N5230A-03A

S E R V I C E N O T E

Supersedes:
N5230A-03

N5230A PNA Microwave Network Analyzers

Figure 1: A3 Front Panel Interface Board Assy without the Bracket

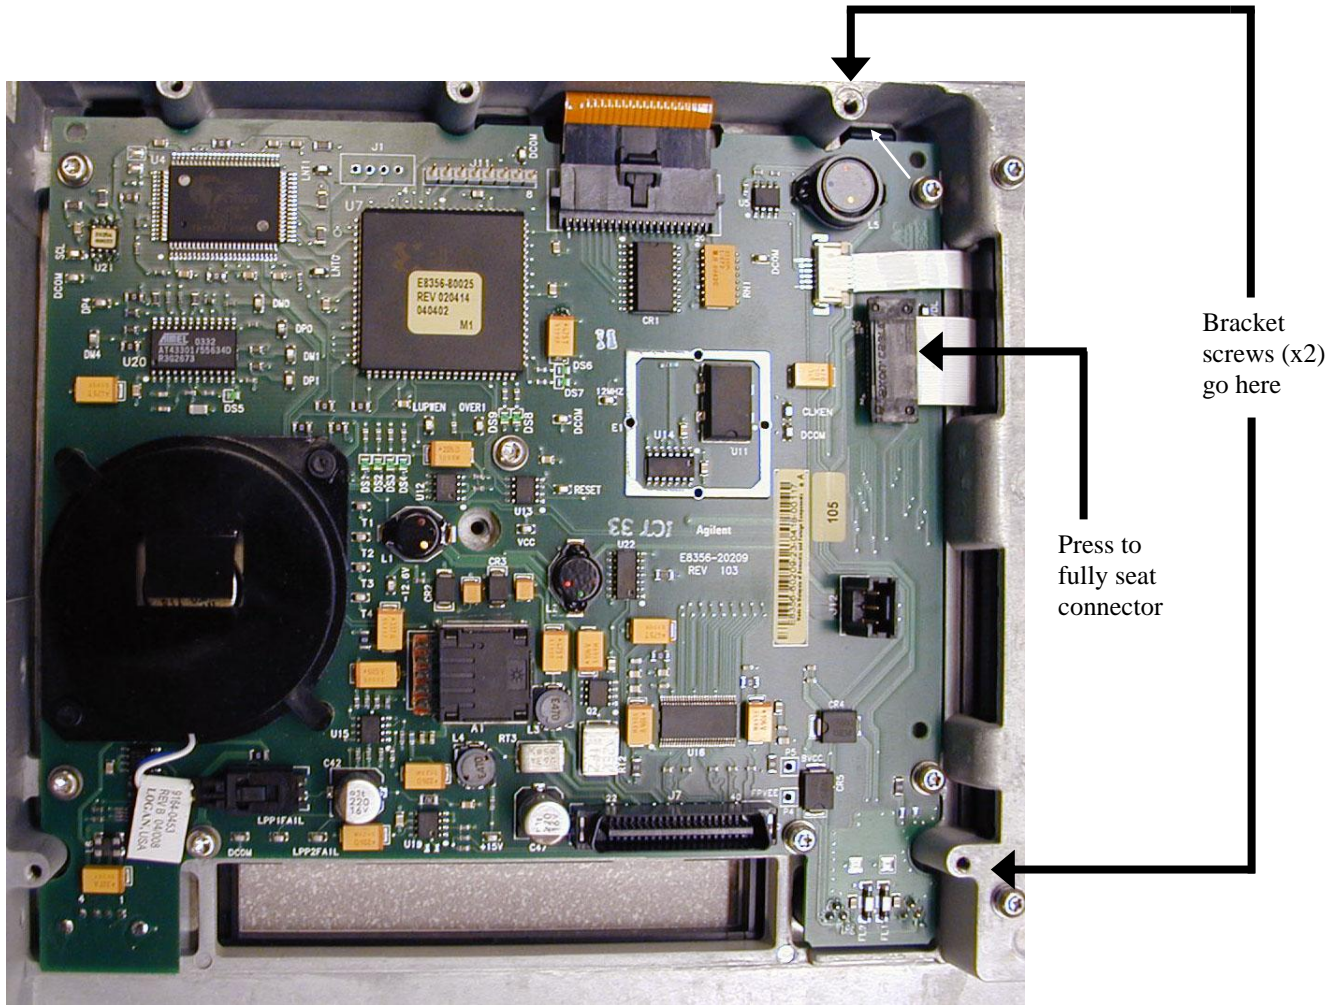
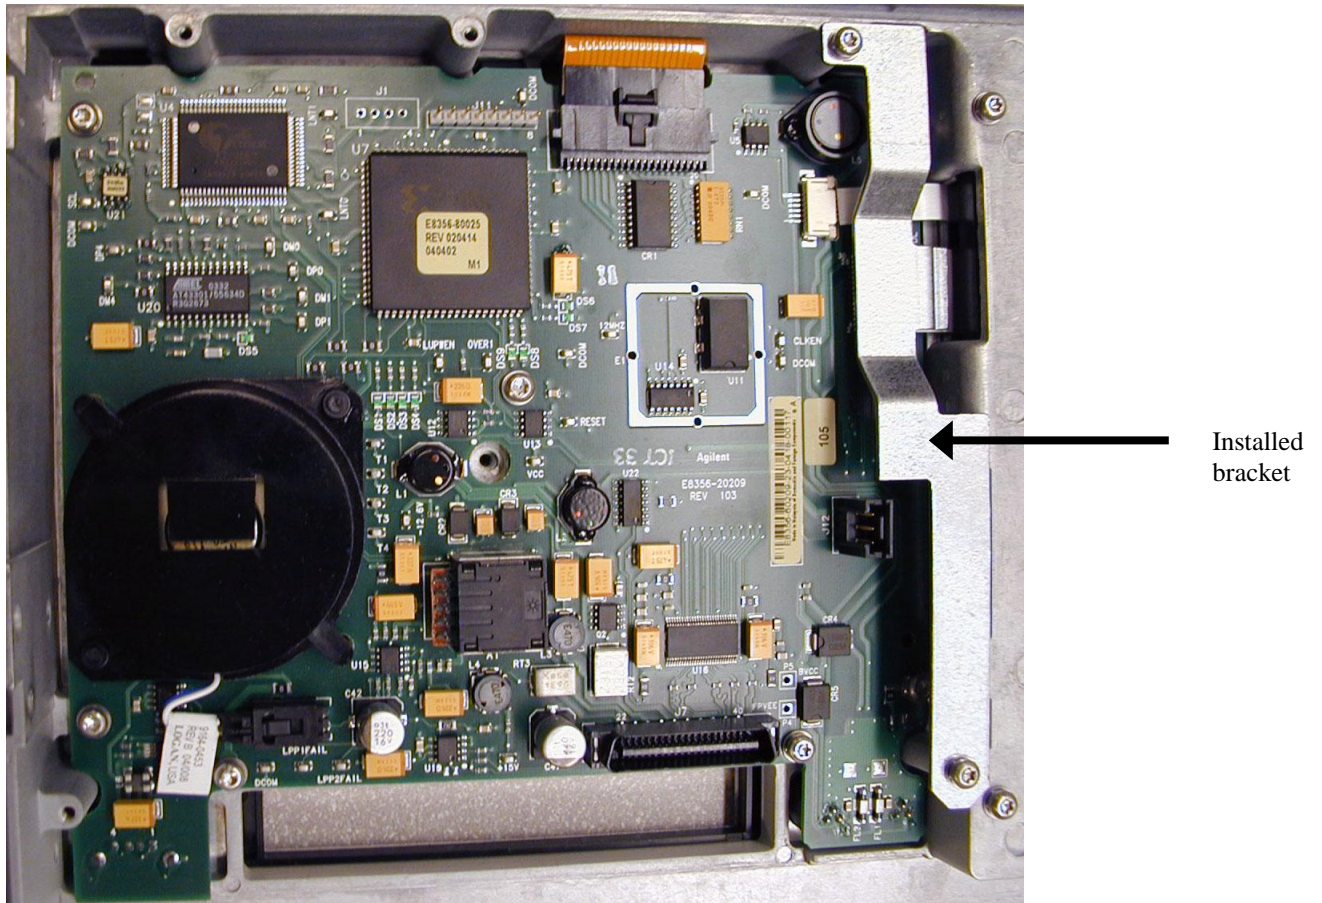
A connector of the ribbon cable (Agilent part number 8120-8409) that joins the front panel display to the front panel interface board can loosen, causing a display failure, unless a new bracket is installed. Because the failure rate has been very low, it is recommended that the bracket be installed only when there is an additional reason to remove the PNA front panel.

1. Refer to Figure 1 in this document:
 - Press down firmly on the ribbon cable's black connector.
 - Locate the two tapped holes for the bracket screws.
2. As shown in Figure 2 in this document, position the bracket so that its holes line-up with the two holes you located in the previous step.
3. Hand-start the two screws, and then torque both to 9 in-lbs.
4. Reinstall the PNA Front Panel by following the Service Guide instructions in the "Replacement Procedure." This is located on the same page as the "Removal Procedure" used previously in step 7.

Use the following procedure to install the bracket on the A3 Front Panel Interface Board Assy.
